First Release

11-04-2019

VOLVO 9700 PTO REPLACEMENT 9700 (B13R)

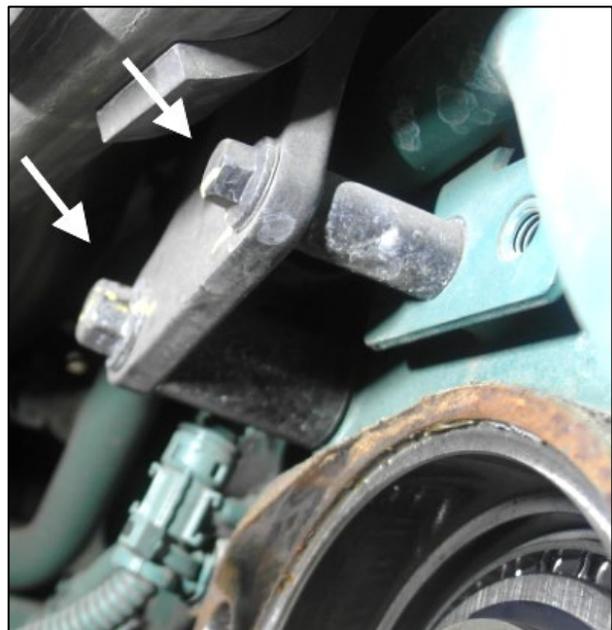
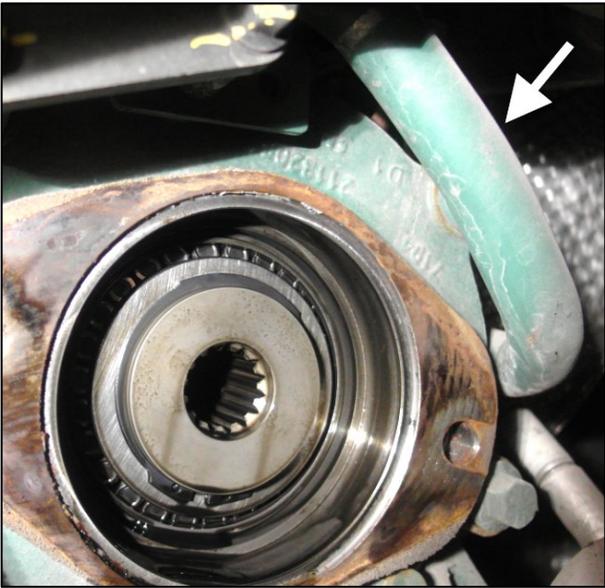
5. Disconnect both hydraulic hoses at the back of the hydraulic pump.

6. Remove the pump from the vehicle (discard pump O-ring).

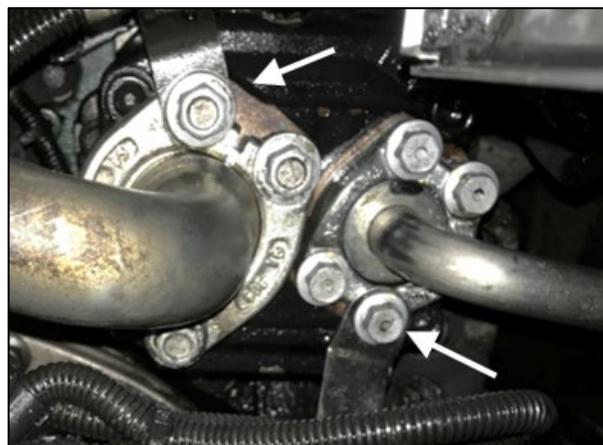
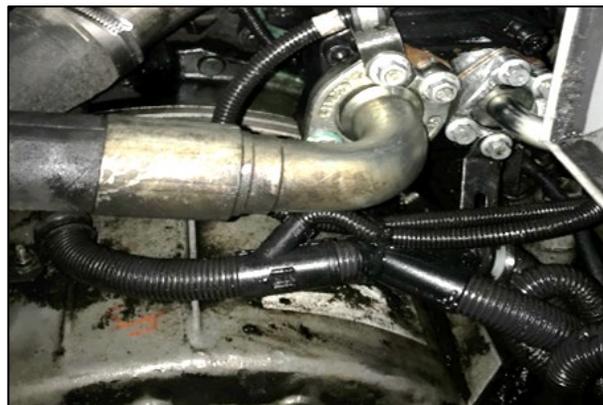
14. Reinstall hydraulic hoses at the back of the pump (also reinstall brackets).

TORQUE: 52 +/-5 Nm (38 +/- 4 lb-ft) in a cross pattern.

- Apply torque seal to the bolt heads.
